POWERHOUSE ULTIMO REVITALISATION

Public Domain
& Landscape
Statement

RTS

Above: Photographs taken during tree root investigation for Tree 17. This investigation resulted in a strategy for bridging key roots with a structural system illustrated on the following page.

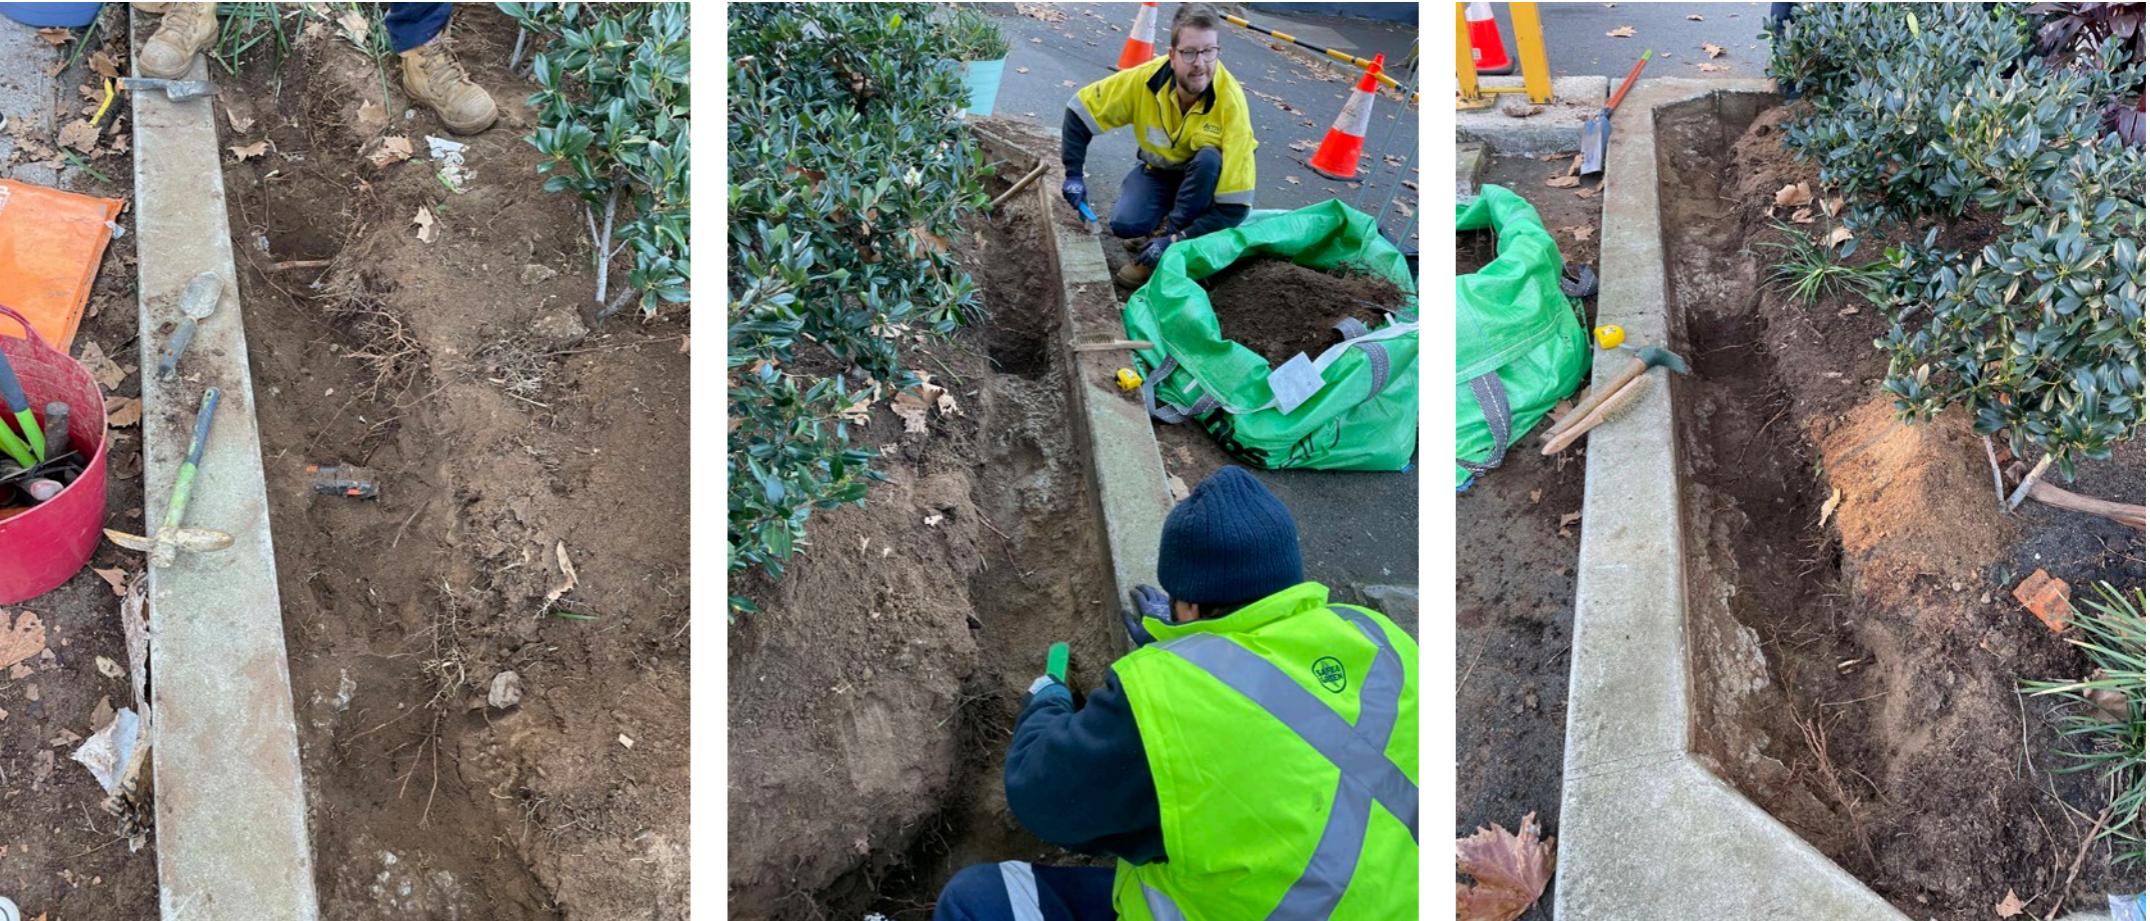
- Tree 17 is a mature Plane Tree in good health, growing in the centre of Macarthur Street.
- Due to constraints, the loading dock entry ramp has been positioned such that vehicles cross the tree root zone.
- Exploratory root investigations have been conducted in the tree pit surrounding Tree 17. This survey has informed the solutions provided to conform with the requirements of Section 3.2.9 of the Arboricultural Impact Assessment.

Above: 3D drawing of the steel plate solution.

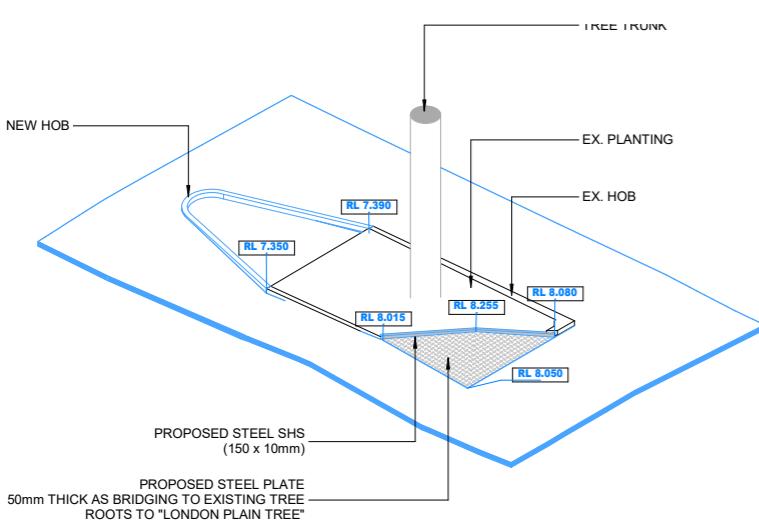
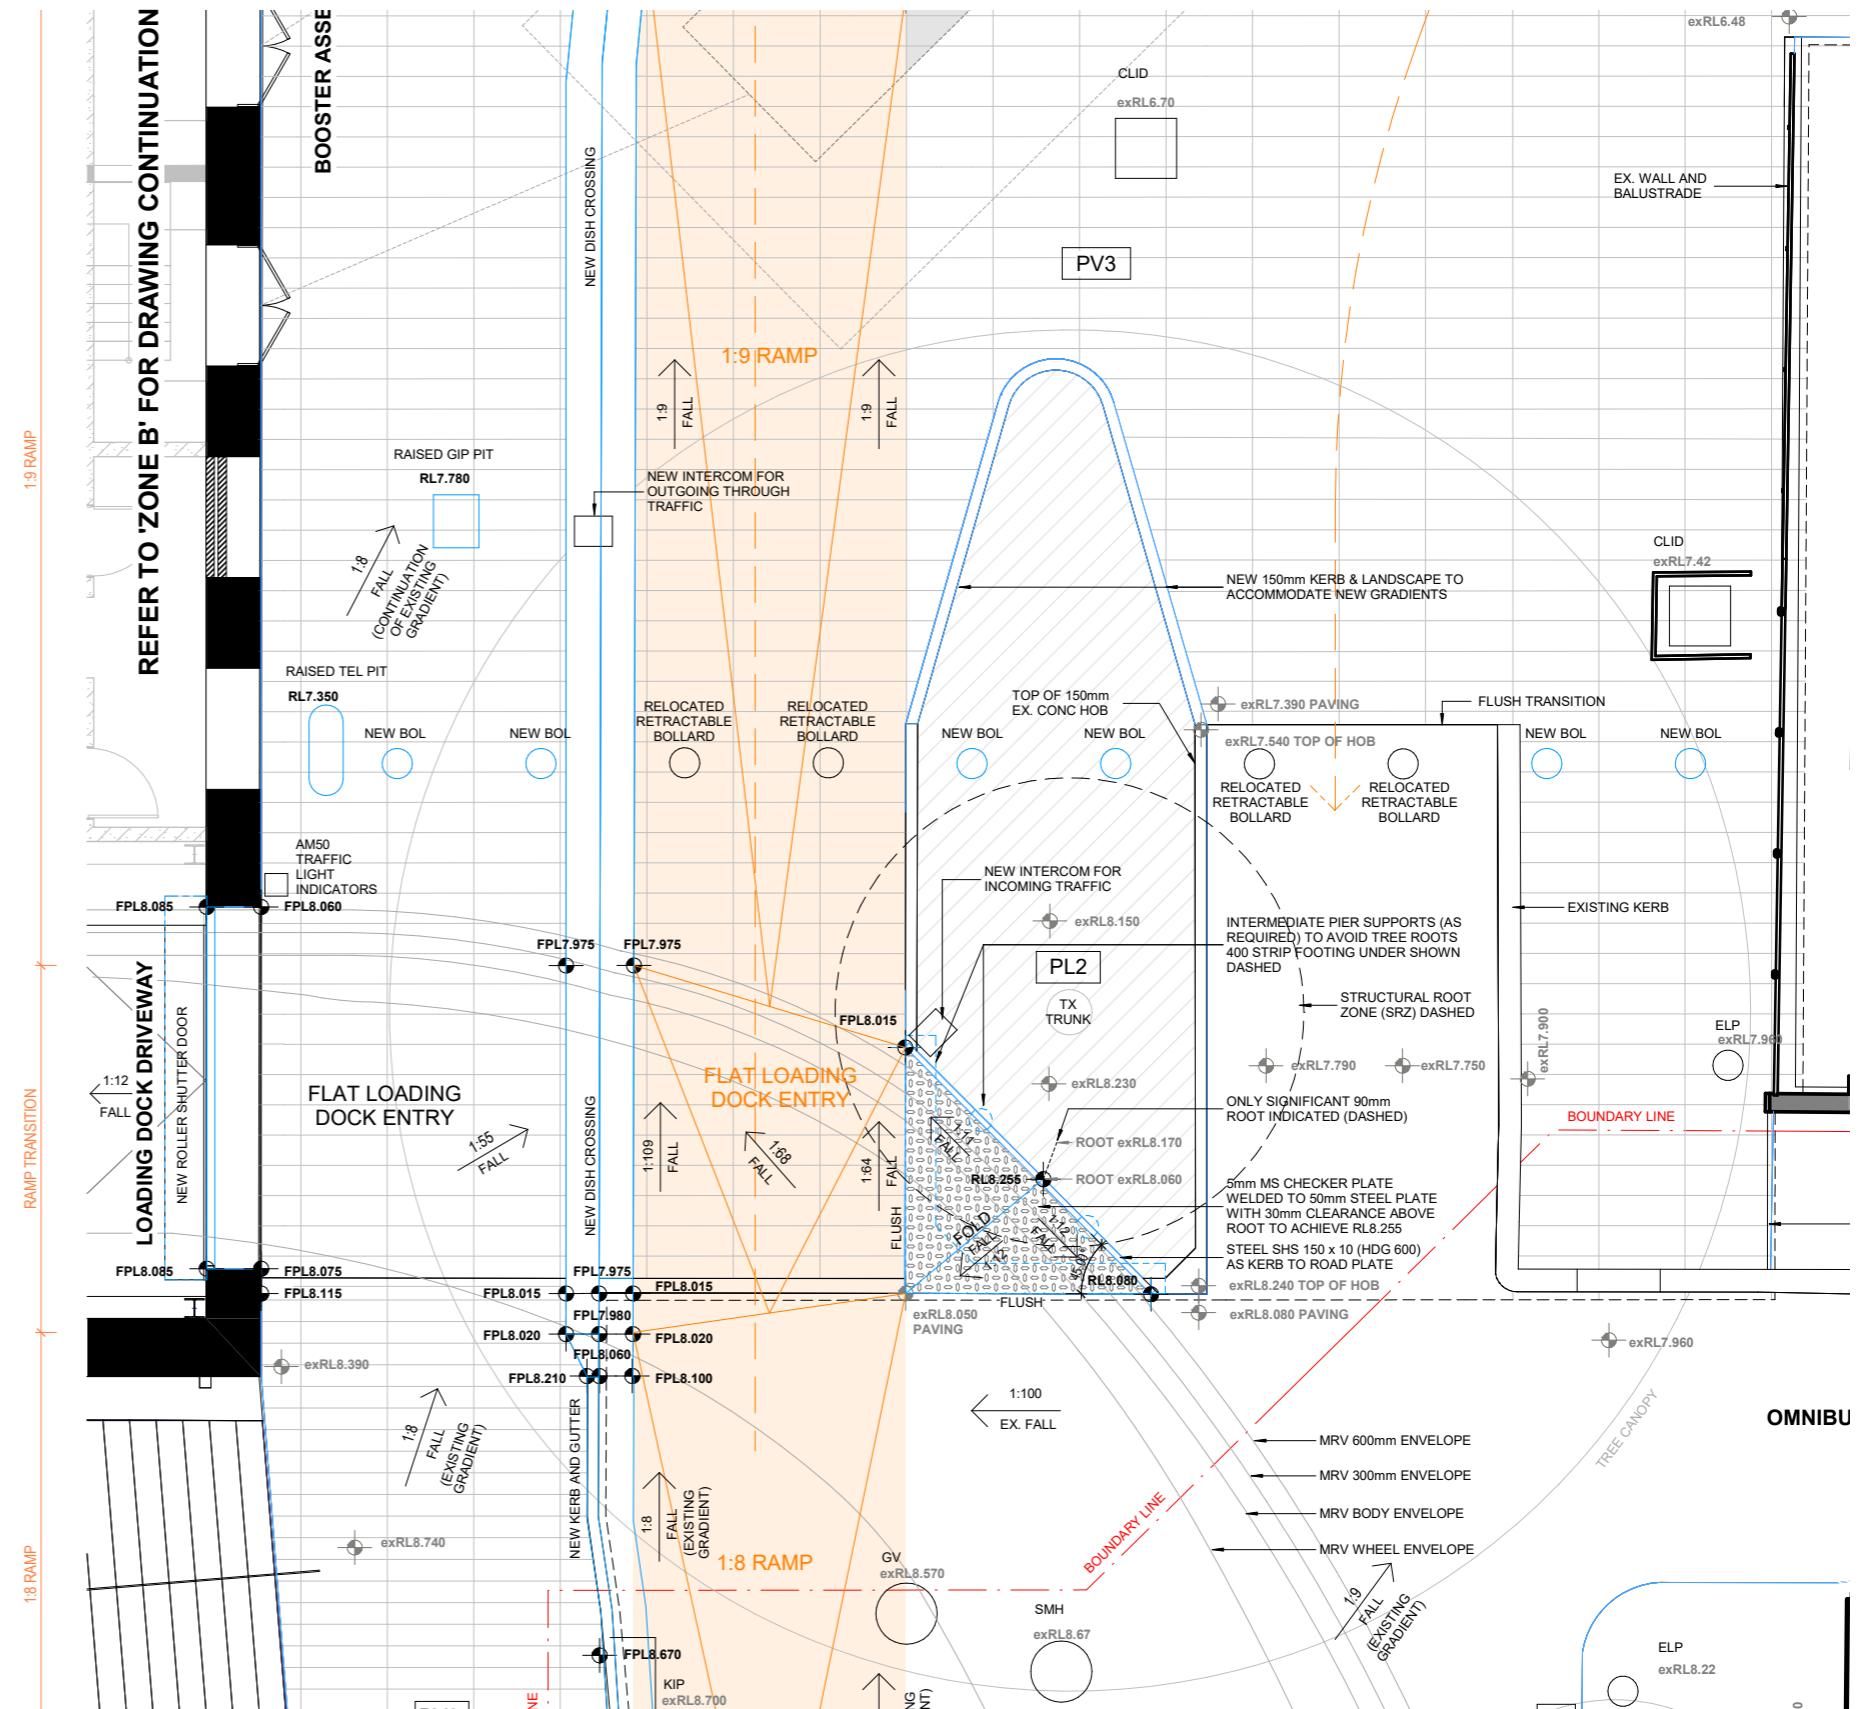
- The solution consists of a structural engineer designed slip-resistant road plate and kerb, bridges the existing roots of the tree to allow for access into the loading dock.
- The design has been developed with the Project Arborist and bridges the structural root zone.
